**PRODUCER STATEMENT – PS4 – CONSTRUCTION REVIEW**

ISSUED BY: Certa Engineering Ltd
TO: Woburn House Body Corporate
(Owner/Developer)
TO BE SUPPLIED TO: Lower Hutt City Council
(Building Consent Authority)
IN RESPECT OF: Seismic Upgarde
(Description of Building Work)
AT: 40-44 Bloomfield Terrace, Lower Hutt
(Address)
Lot: DP:

SITE INSPECTION REPORT

Date: 27/10/15	Report No: SR01	Job No: 40166
Inspected By: Gareth Langdon		
Contractors Representative: Paul and Graham (Armstrong Downes)		
Project: Woburn House, 44 Bloomfield Terrace	Area Inspected: Building Walkover	
Inspection time: 3pm		
Weather: Overcast, Dry		
Stage: Building Walkover

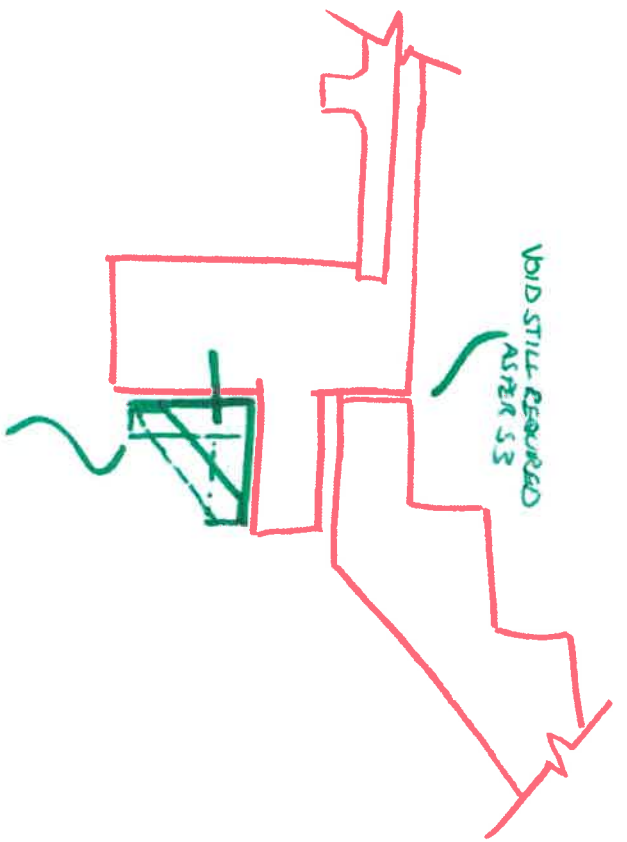
1. Opening up works have commenced to the underside of the concrete stairs, in the area required to be supported by the steel brackets.
2. Detail supporting stairs is not as per existing drawings. There is a significant, homogenous ledge which supports the base of the stairs, two locations have been opened so far.
3. Stairs are in two sections, split along the length.
4. Ground floor connection appears to be bearing only.
5. Custom Reid-brace on column (C 22) has been installed.

1. From site observation, it would appear that the designed steel brackets are not required in the exact location designed for. Due to the concrete ledge providing adequate seating for the bottom of the stairs.
2. Due to the unknown detailing of the reinforcing contained within the ledge it would be prudent to install a smaller bracket under the ledge whilst reducing the size of the overall bracket to support the ledge.
3. Assuming the ledge detail is the same up the building, the top bracket detail will no longer be required.
4. Subsequently, the revised, smaller, bracket at the bottom of each flight will be required at all levels.
5. Due to unknown nature of the connection between the ground floor slab and bottom of the lowest flights of stairs, it is still recommended to install the slip joint as previously shown.

REDUCED SIZE BRACKETS
LOCATED UNDER EXISTING
LEDGE. 1-M20 CHEMSET
ANCHOR.
INTUMESCENT COATING AS
PER S3.

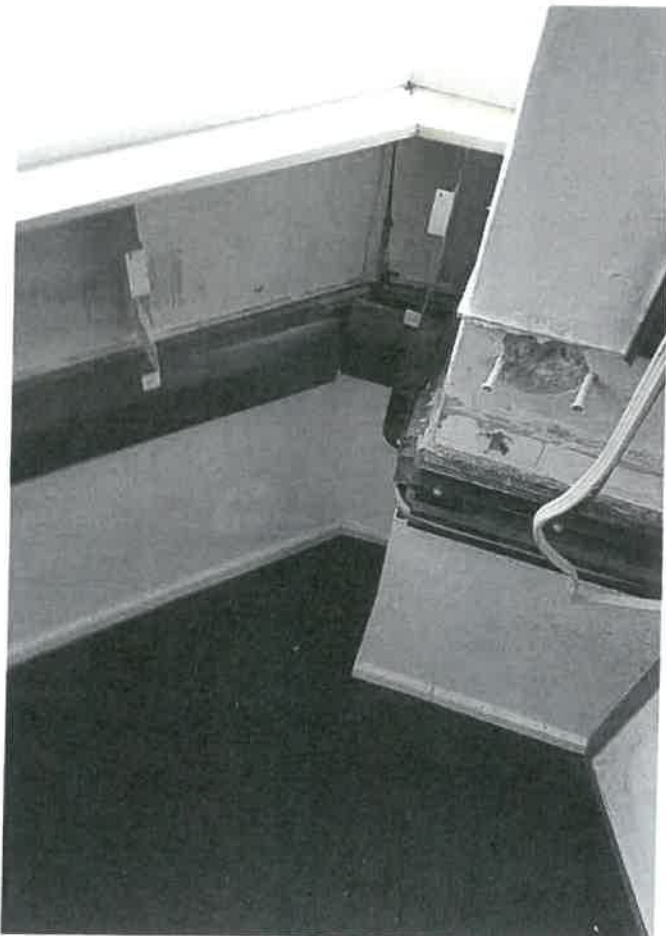
1. Ground floor columns are on site and being installed, adjacent to C 1 and C 19.
2. Due to cladding clashes the location of the columns cannot be precisely where shown on the drawings
3. First floor columns location will clash with existing canopy steel support brackets
4. Second floor column locations appear to be clashing with block-work, opening up is still required to confirm this.
5. Internal columns have been prepared or have been wrapped in FRP.
6. Reid-brace brackets being installed after column wrapping has been completed.

1. On the ground floor, the location of the columns near to C 1 and C 19 are not critical, relocation for installation purposes is acceptable ensuring the beam above is supported in the columns relocated position.
2. On the first floor, the columns will require relocating away from the existing concrete columns to avoid clashing with the existing steel canopy support brackets, this will require them moving into the window area, every effort should be made to line up the column with the existing window mullions to lessen the effect.
3. On the second floor, the columns may well clash with block-work or window framing opening up is required before any issues can be addressed fully.
4. On the second floor there may be a step out between the floor and ceiling beams, this may require a step out or a custom plate being fitted, again opening up is required before addressing this possible issue.
